Project: IEEE P802.15 Working Group for Wireless Personal Area Networks (WPANs)

Submission Title: [Some discussion for LB #57 comment resolution of Annex G]

Abstract: [This document describes the LB #57 comment resolutions related to Annex G]

LB #57 comment resolutions related to Annex G

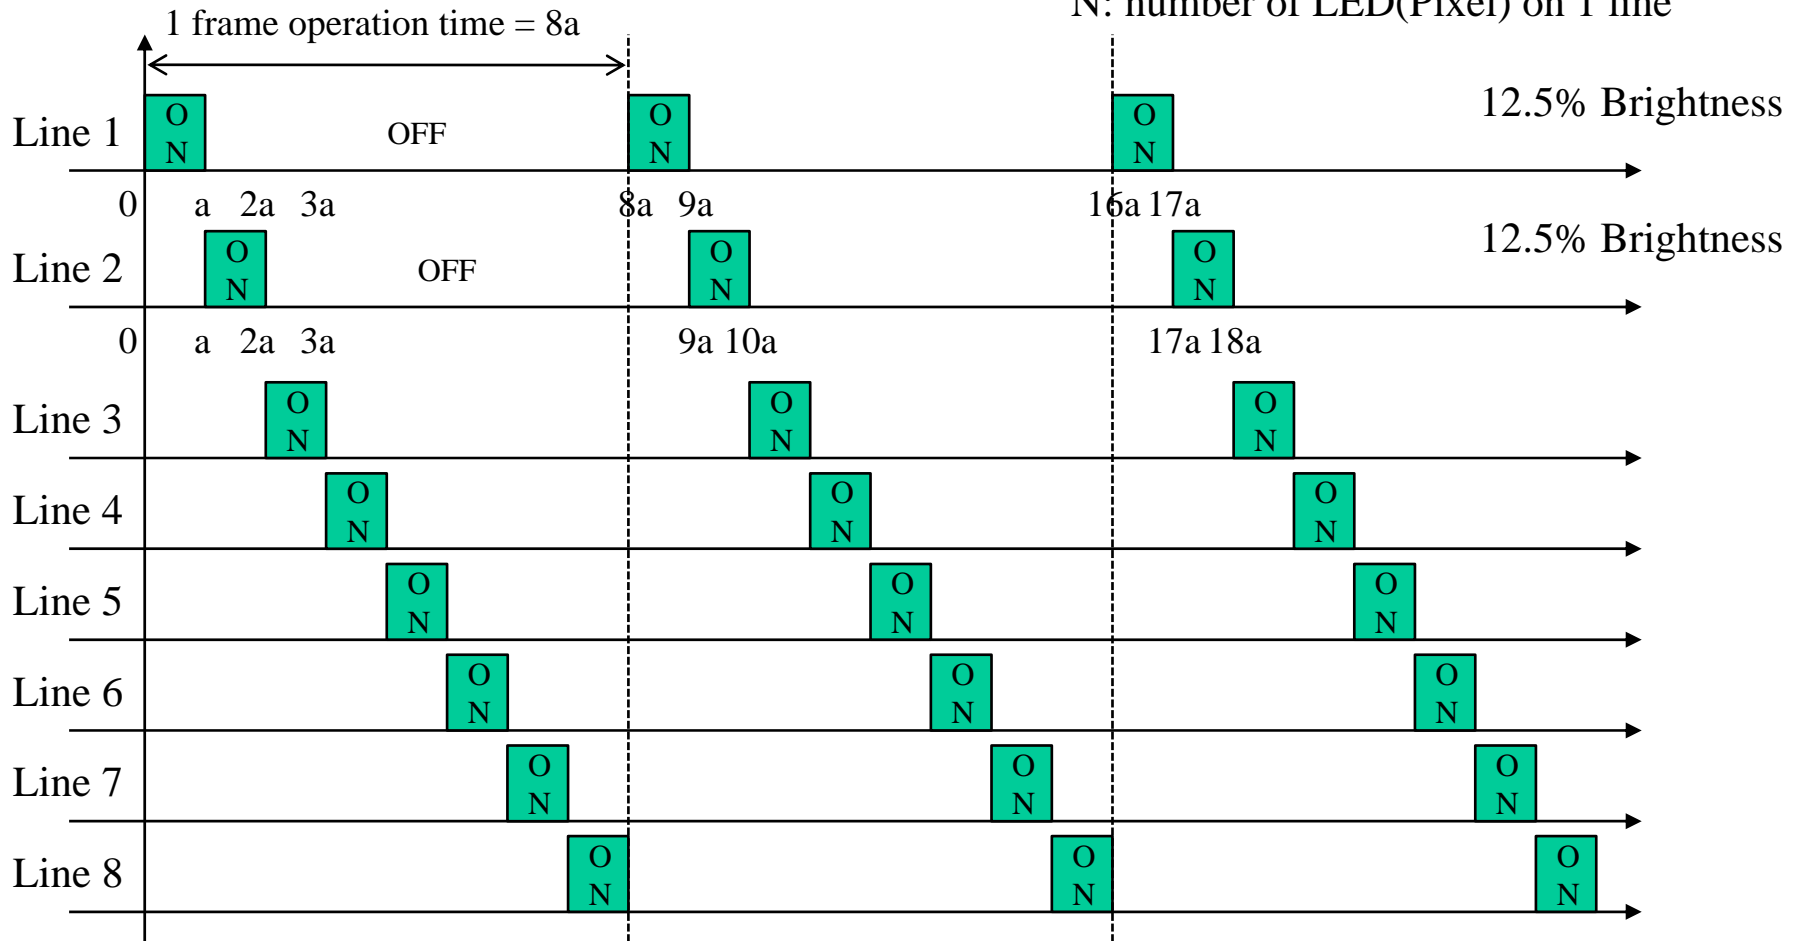
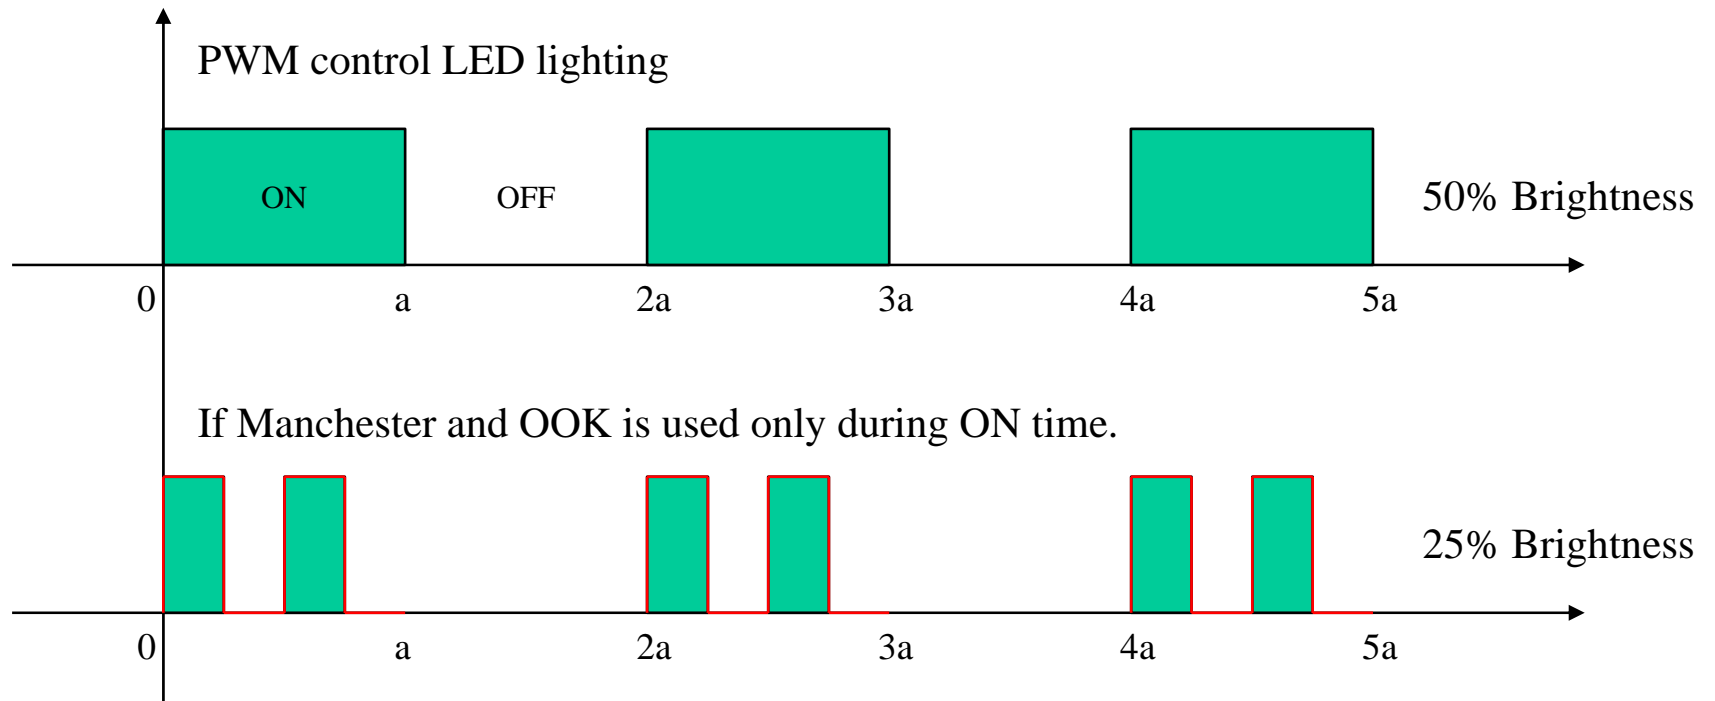
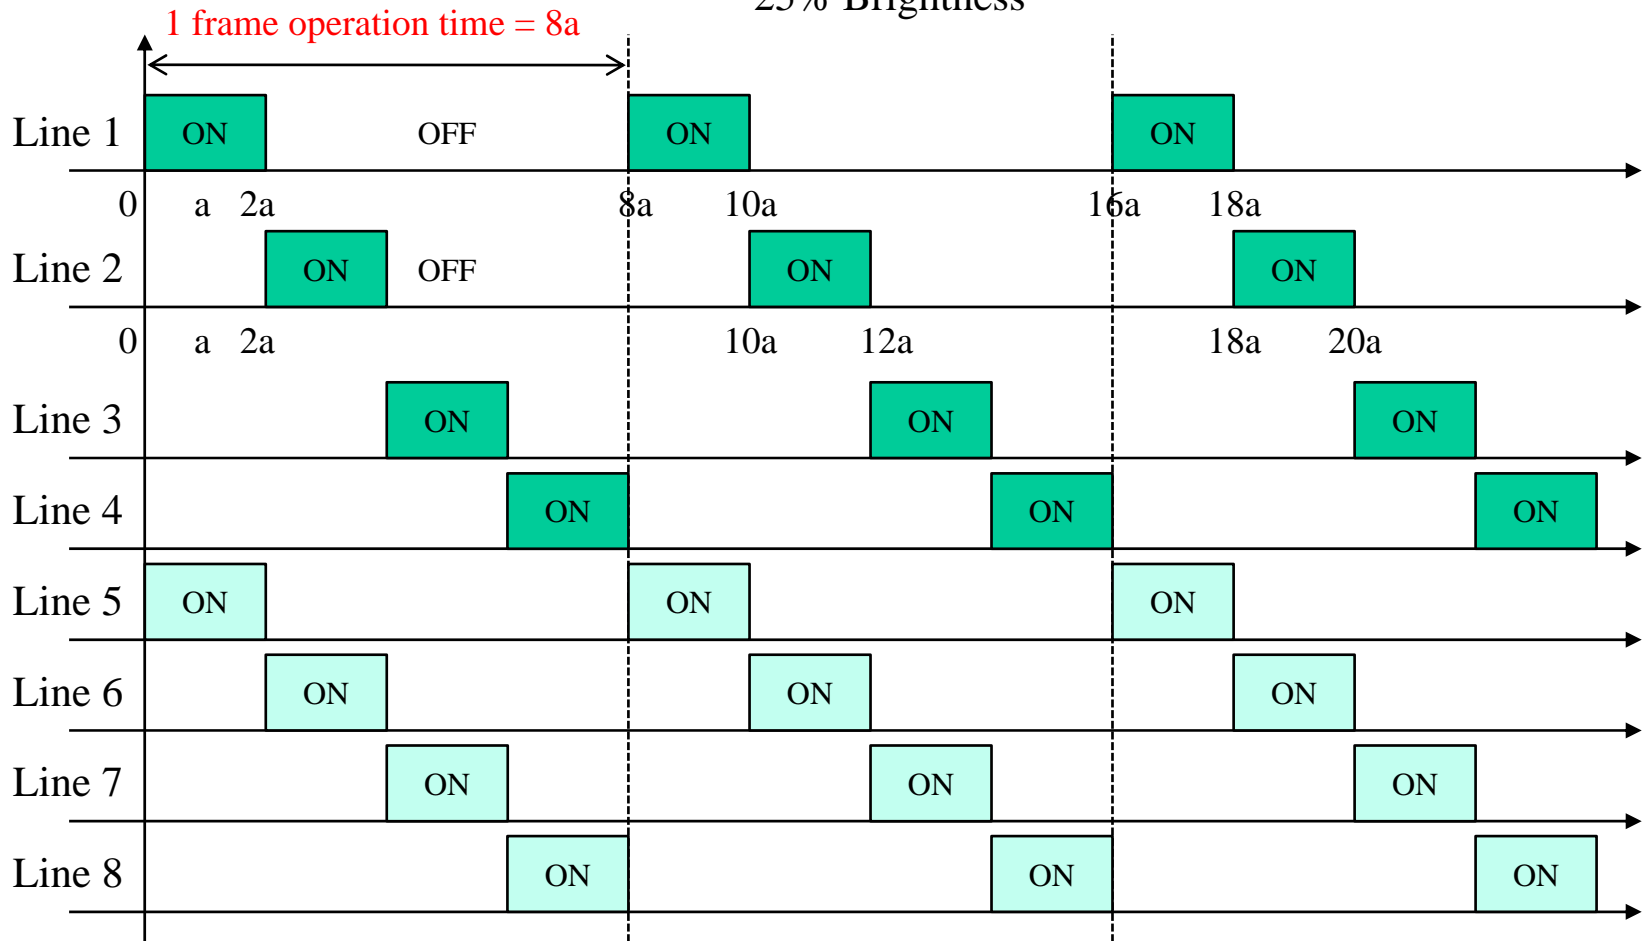
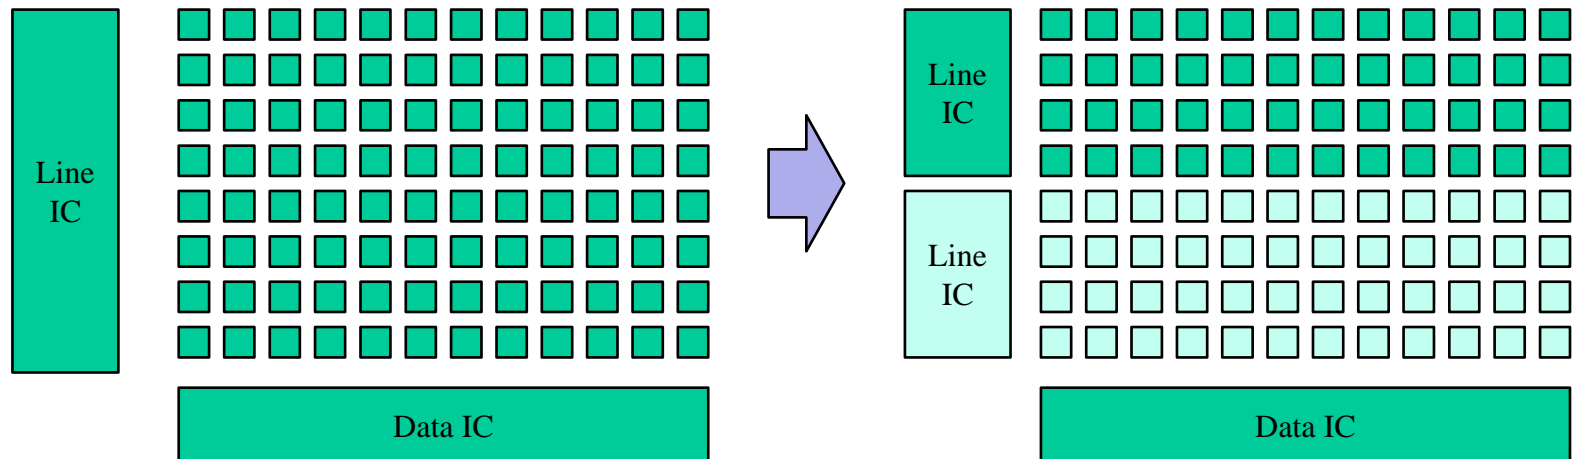
CID	Name	Clause	Subclause	Page	Line	Comment	SuggestedRemedy
408	Rick Roberts	Annex G	Table 91	298	45.5	"potentially faulty reasoning ... more likely I don't understand the thinking! The text says: To maintain the same brightness, even though the VLC data stream reduces the brightness by half, the operating time per line needs to be increased such that 100% duty of 1ms = 50% duty of 2ms = 1ms ON time per second."	The implication is that by reducing the number of pixels per line from 16 to 8, and hence increasing the time duration per pixel by a factor of 2x, then the average intensity will remain the same as the unmodulated case is probably not true. As long as the modulation rate is greater than the flicker frequency threshold, the intensity is decreased by 50% for 100% extinction ratio regardless of the time duration of the pixel, and also regardless of the data rate. At least that is what I think. So my comment is the text at the bottom of page 298 is potentially flawed ... as to the implications on the material in annex G, I don't know that. Committee discussion.

- The total brightness during unit time period perceived by human eye of the VLC signboard can be reduced less than that of the non-VLC signboard. Therefore, it is important to minimize the perceivable brightness weakness on VLC applications using LED signboard because the LED signboard should keep the display function as its inherent role.

- Operation time for 1 line is fixed = 8a
- Number of line controlled by line IC is decreased 8 to 4

Figure G.5. An example of broadcast topology construction on VLC LED signboard

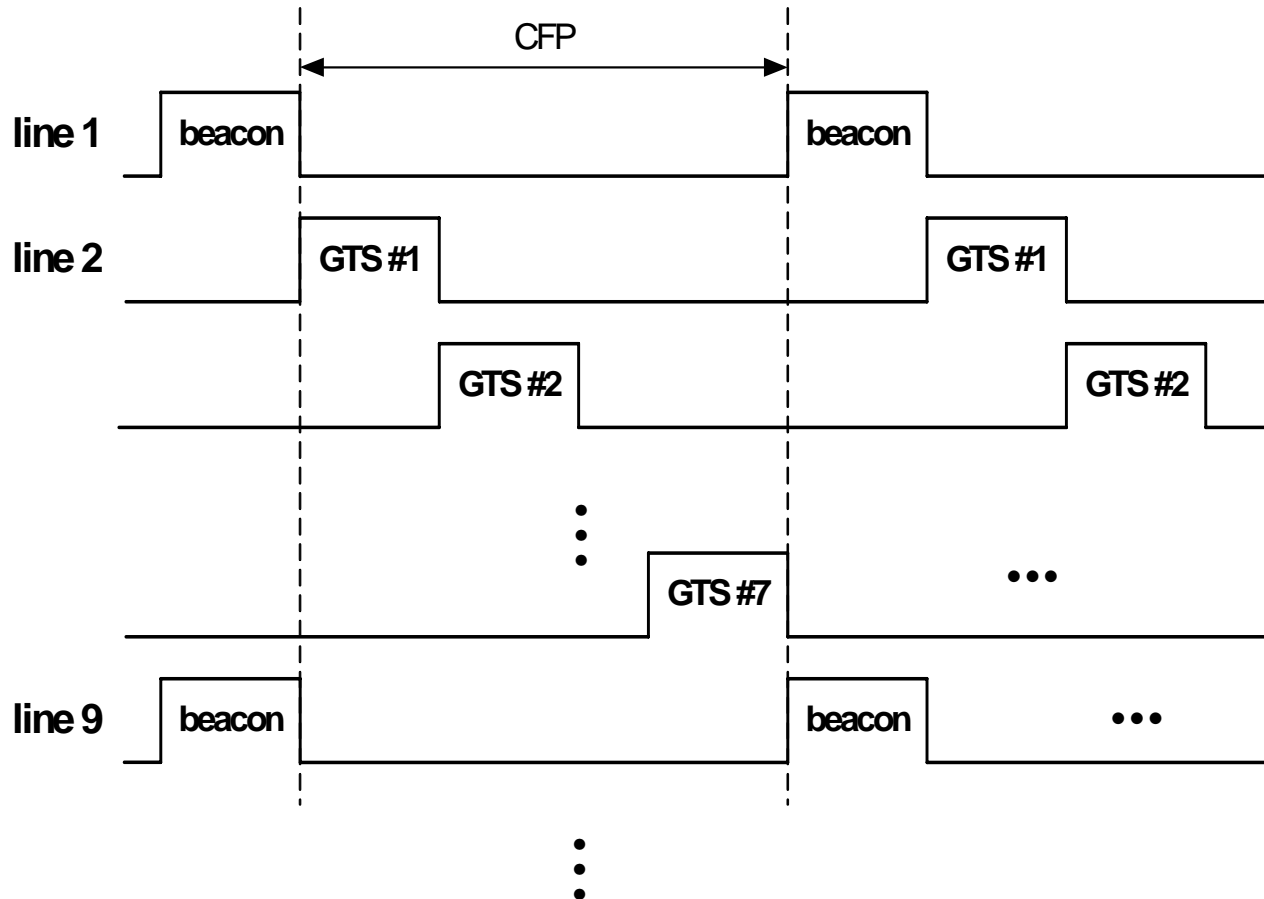
CID	Name	Clause	Subclause	Page	Line	Comment	SuggestedRemedy
410	Rick Roberts	Annex G	Table 91	300	1	modify text as shown in remedy	" ... QoS policy by multiple slot allocations according to the service level as shown in subclause 6.2.2.1. The TDM time slot consists of the beacon slot and the data slot. The beacon slot TS0 is a VLC header for compatibility information with the source address and the destination address, the length field of beacon slot, the service type (information broadcast service or data download service) and the time slot information. The data slot from TS1 to the end of TS is simply the header with the destination address (only for data download service) and no length field."

- The text has been modified and a Figure for the understandings has been inserted.

- The VLC LED signboard can be useful for the broadcast topology. The VLC broadcast topology in this standard consists of mainly the beacon and the downlink, as shown in Figure 106. Therefore, a broadcast topology can be constructed by assigning the active time slot #1 to the beacon and the active time slots from #2 to #8 to the downlink as shown in Figure G.5 and the use of GTS fields in the beacon frame.
- The GTS fields of beacon frame can be used to indicate the GTS number, GTS length, and GTS direction for the broadcast topology. The multiple GTS slot can also be used, which depends on the service level, the subscriber's grade, and the QoS policy.
